CITY OF
EAST GRAND RAPIDS

RE: Gaslight Investors – Revised Concept Plan and Draft Ordinance & Resolution.

PUD AMENDMENT CONCEPT PLAN

RE: **Gaslight Investors Planned Unit Development Amendment Introduction**
2255 Wealthy St. SE and 515 Lakeside Dr. SE (PPNs 41-14-33-276-032 and 41-14-33-276-029)

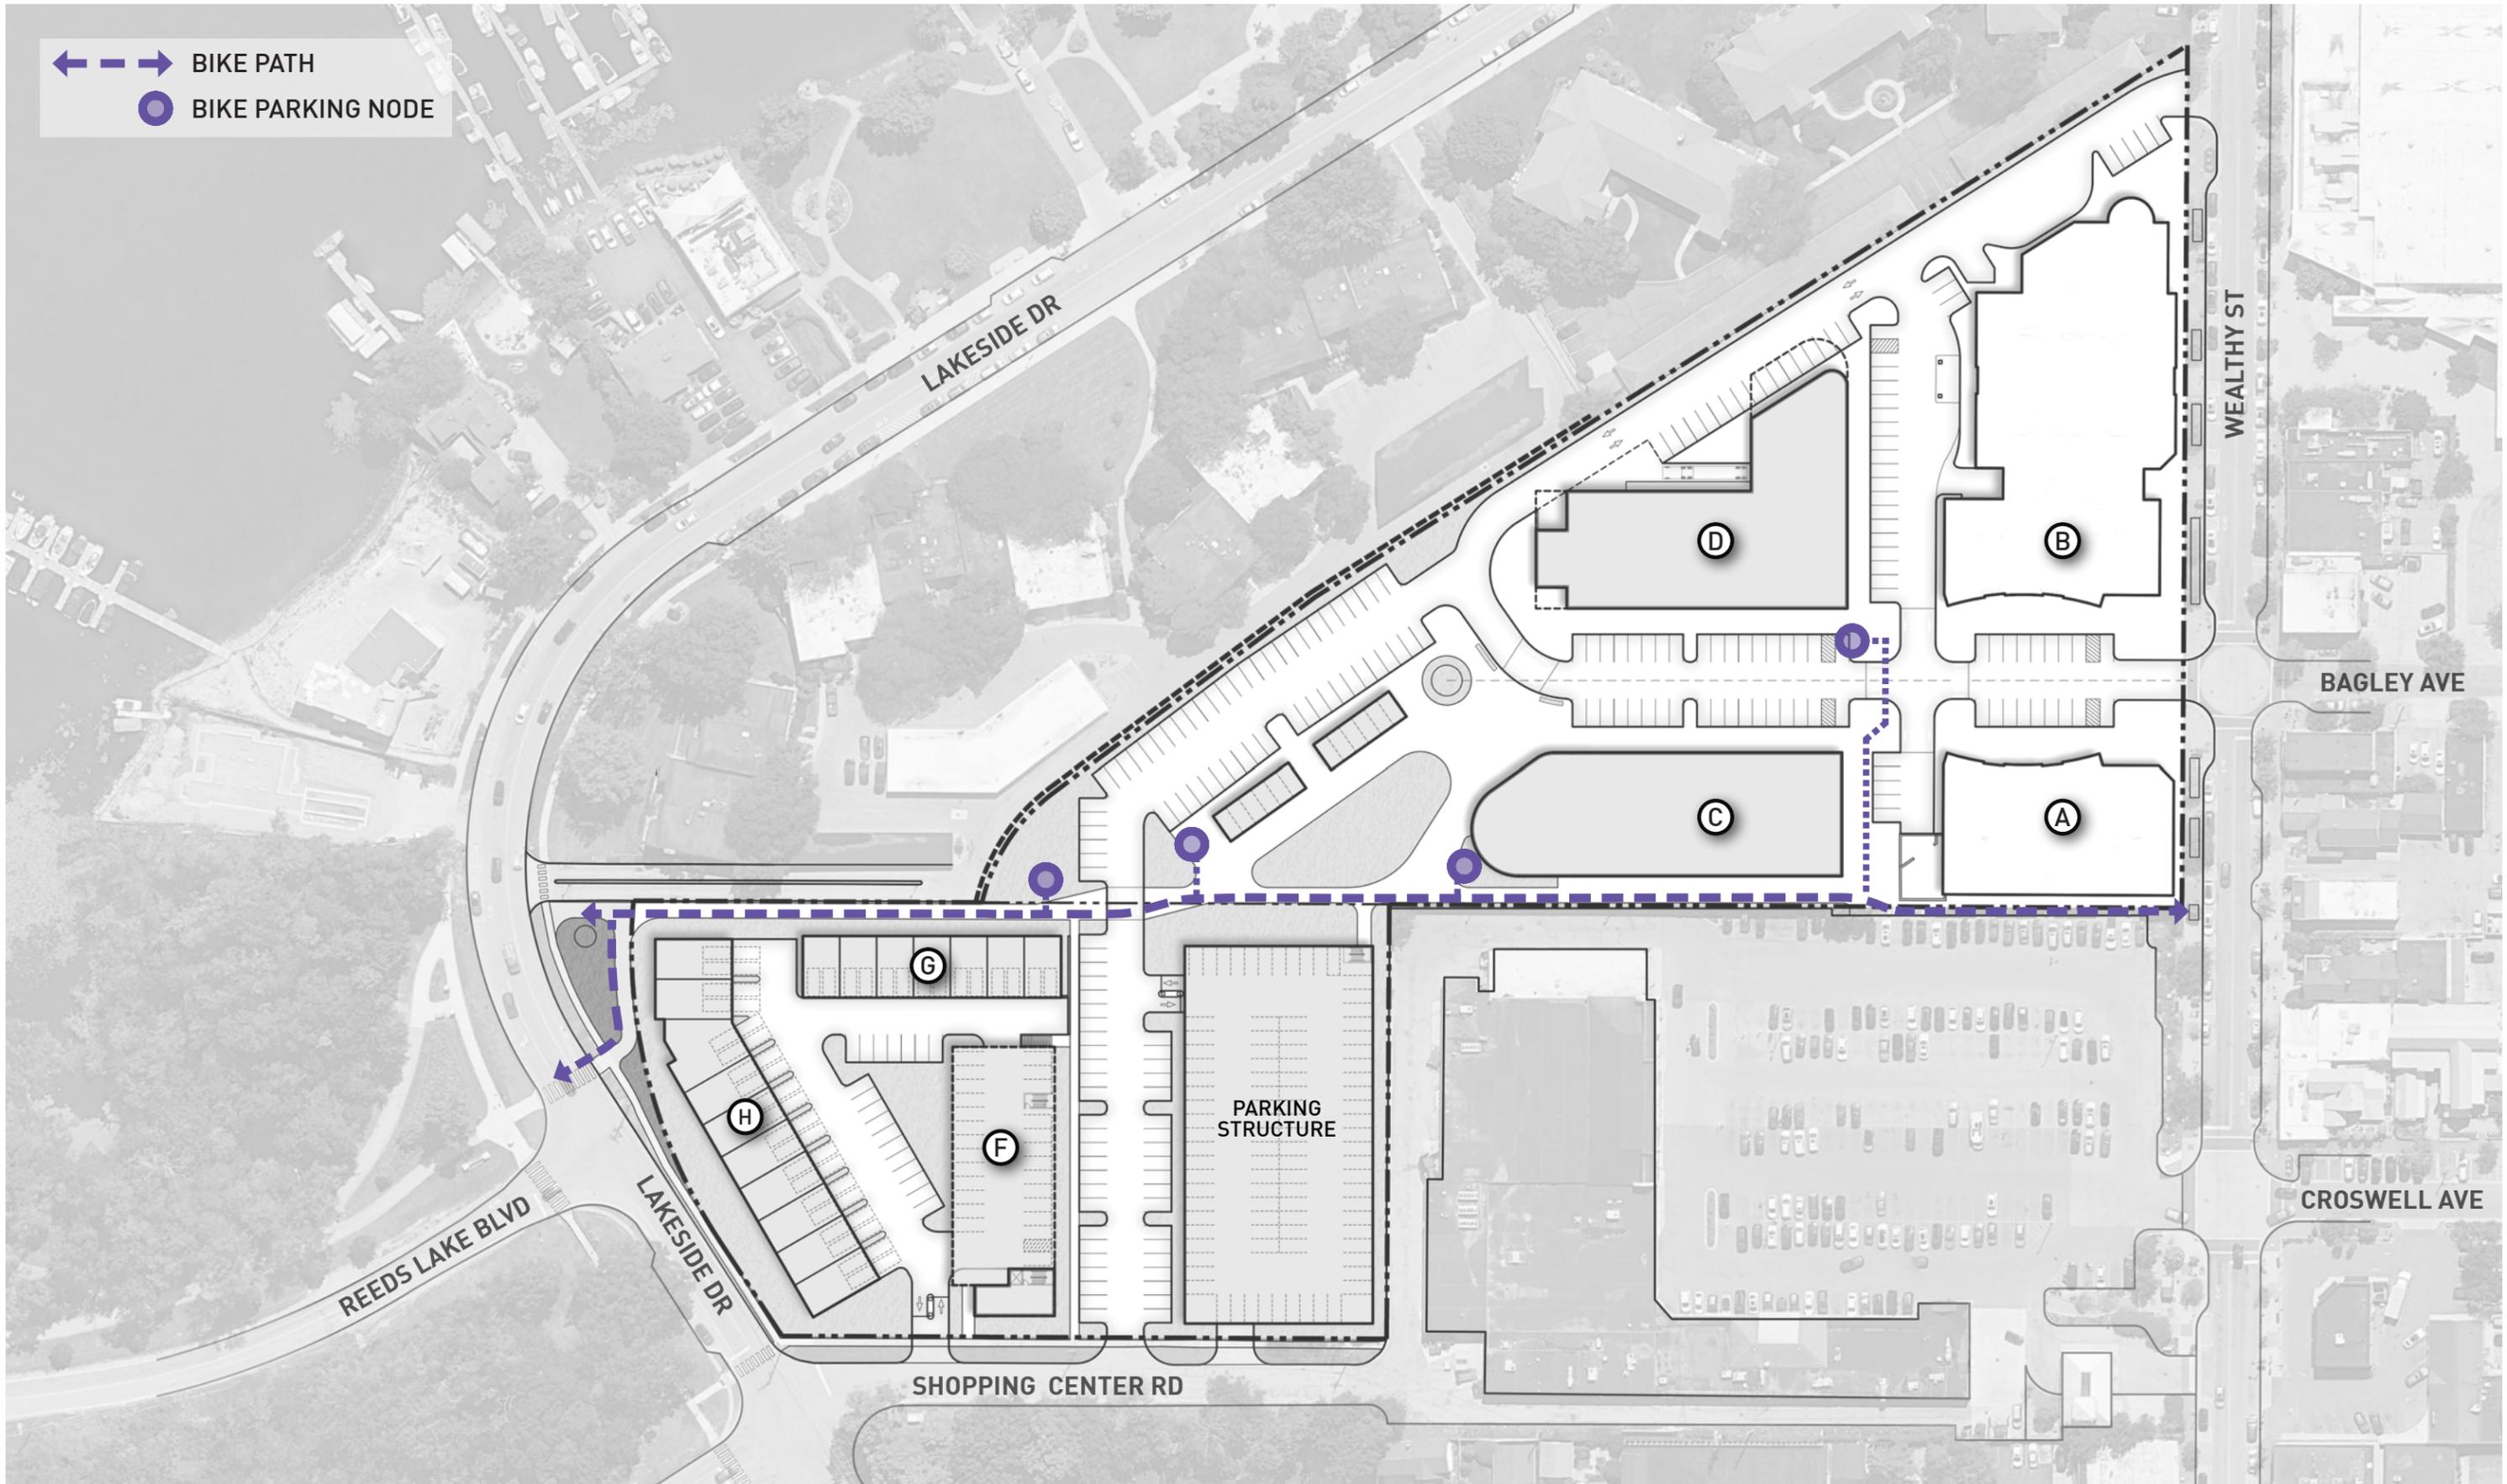
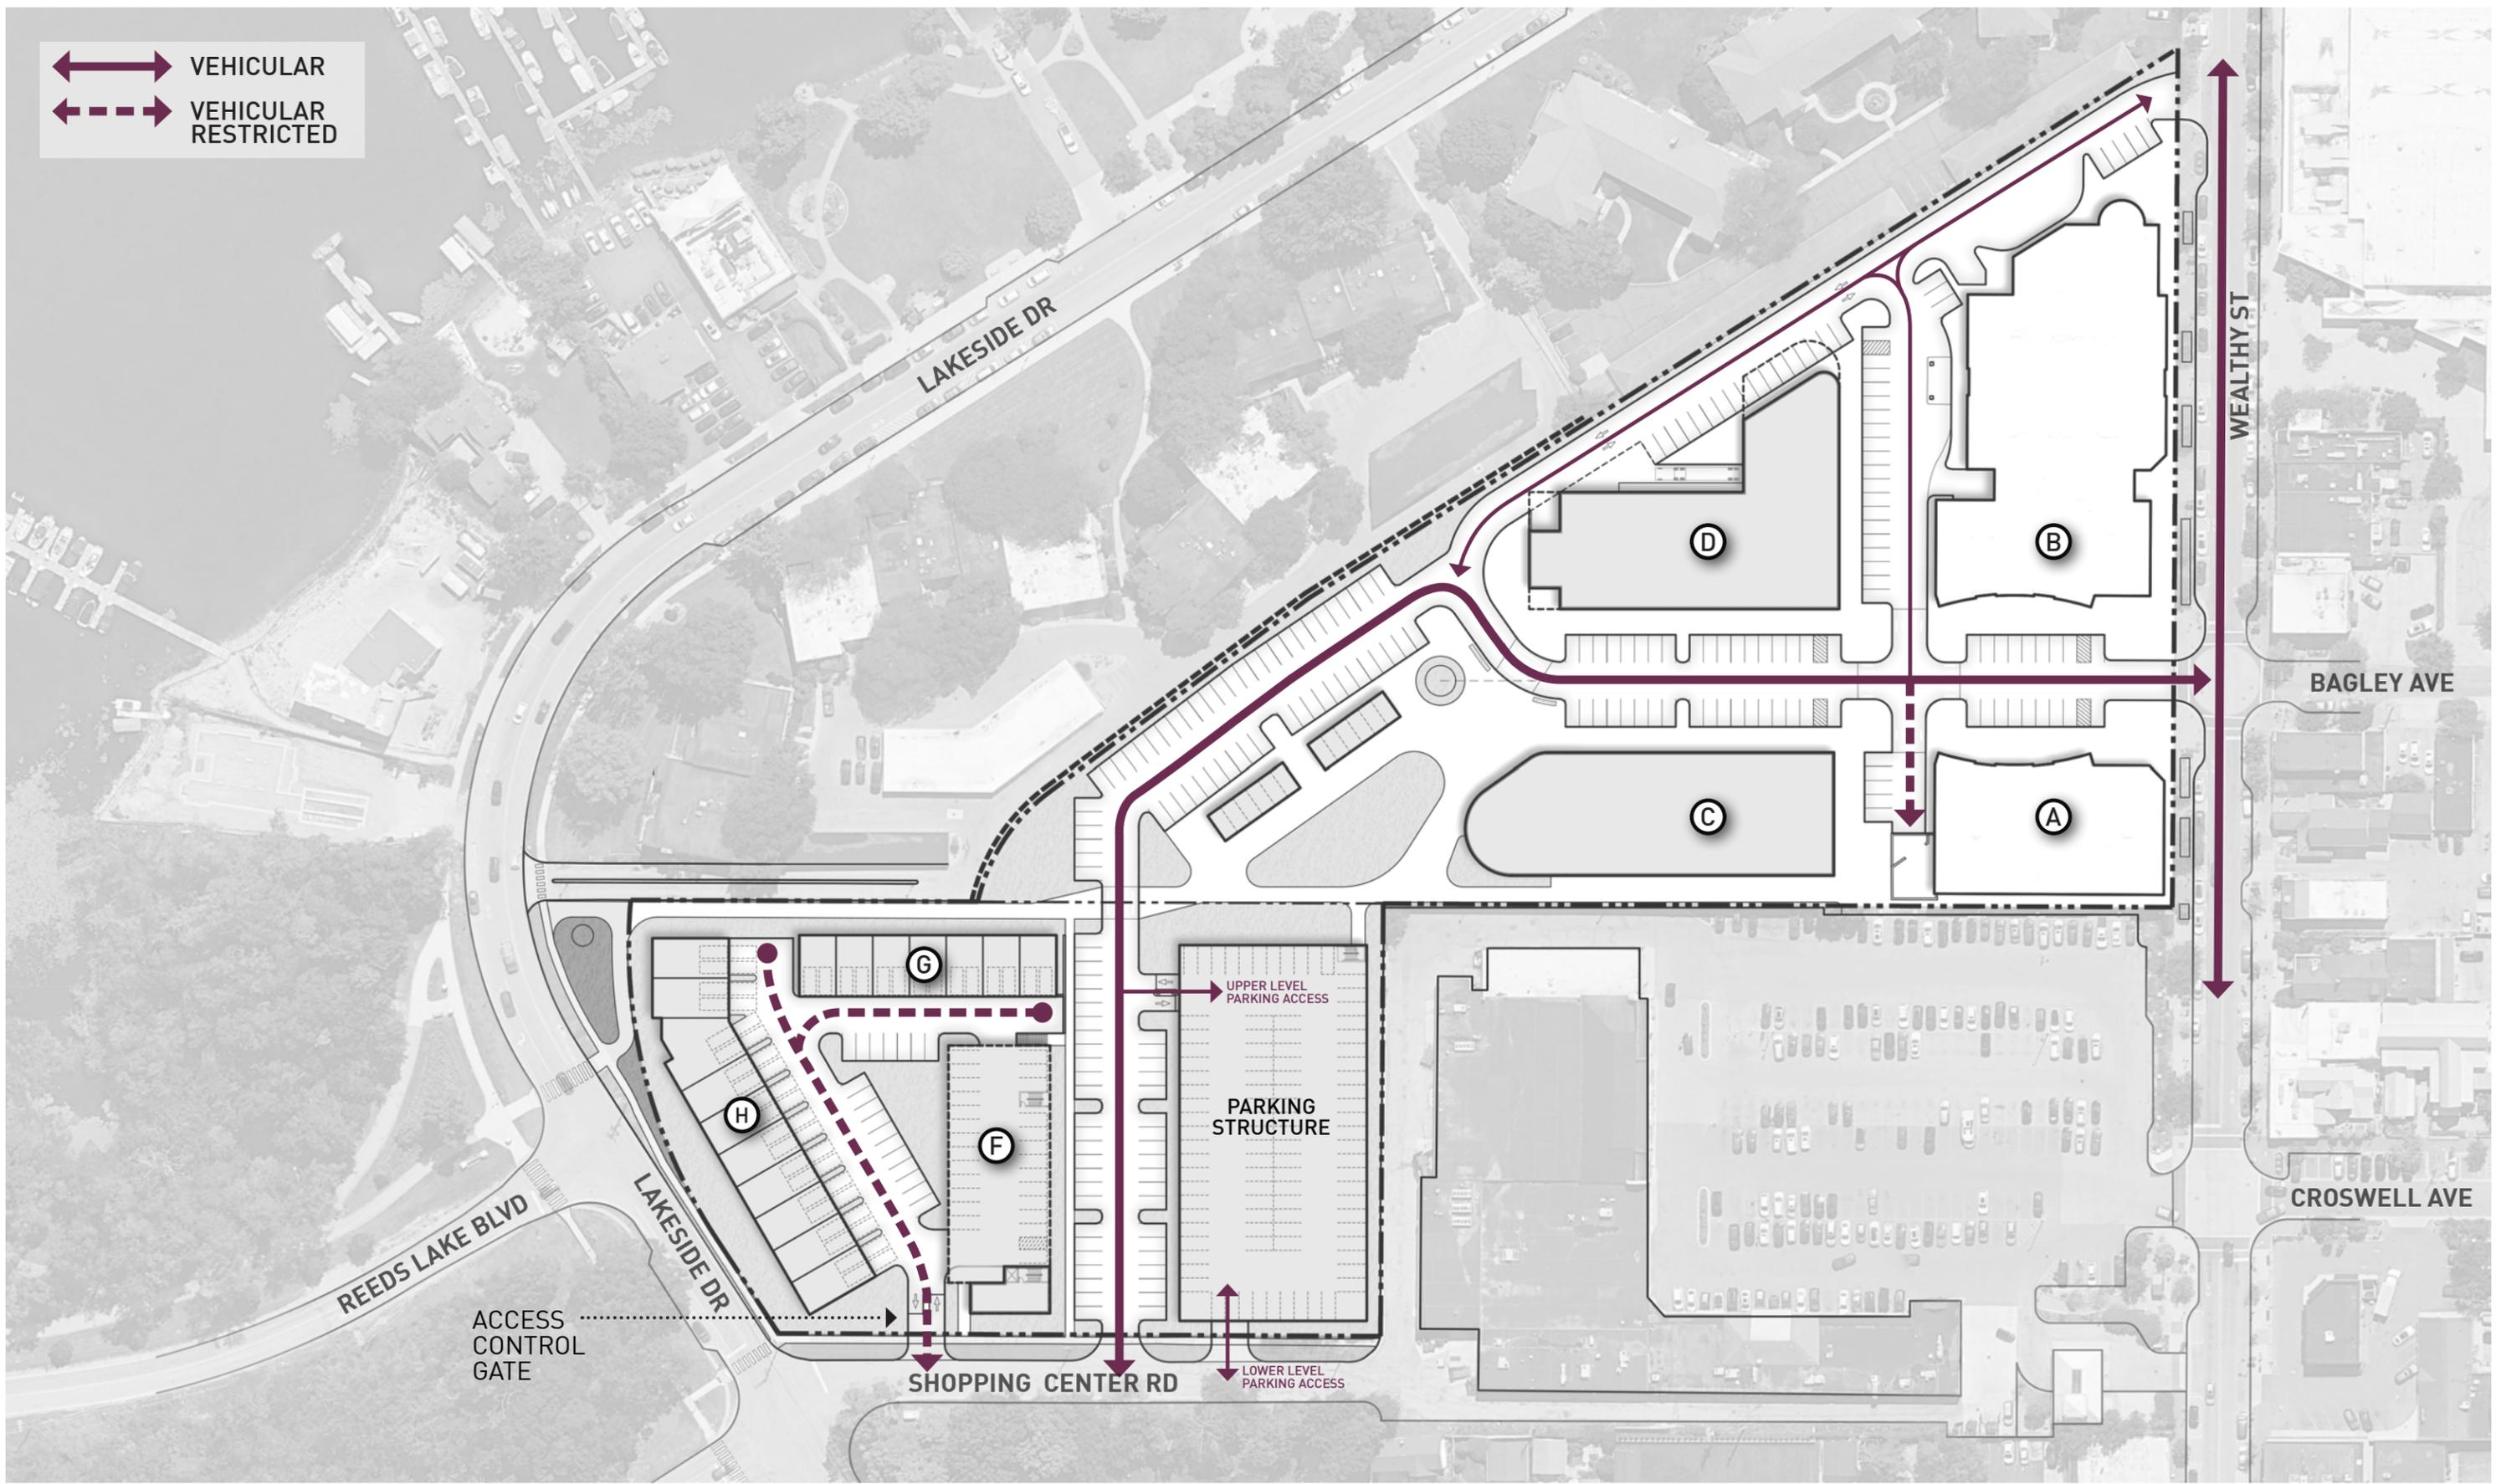
The applicants have also provided basic renderings and diagrams showing the general circulation routes for different users. Of note, the proposed bicycle circulation drawing shows a main north-south bike route connecting Lakeside and Wealthy without intermingling with the internal road network. Access points to bike rack stations are noted and would utilize other planned pedestrian infrastructure. Otherwise, these

drawings do not provide much detail on what specific types of amenities will be incorporated. The City has recommended adopting various recommendations from the National Association of City Transportation Officials (NACTO) and other professional engineering design manuals in other areas such as pedestrian pathways and integrated public amenities.
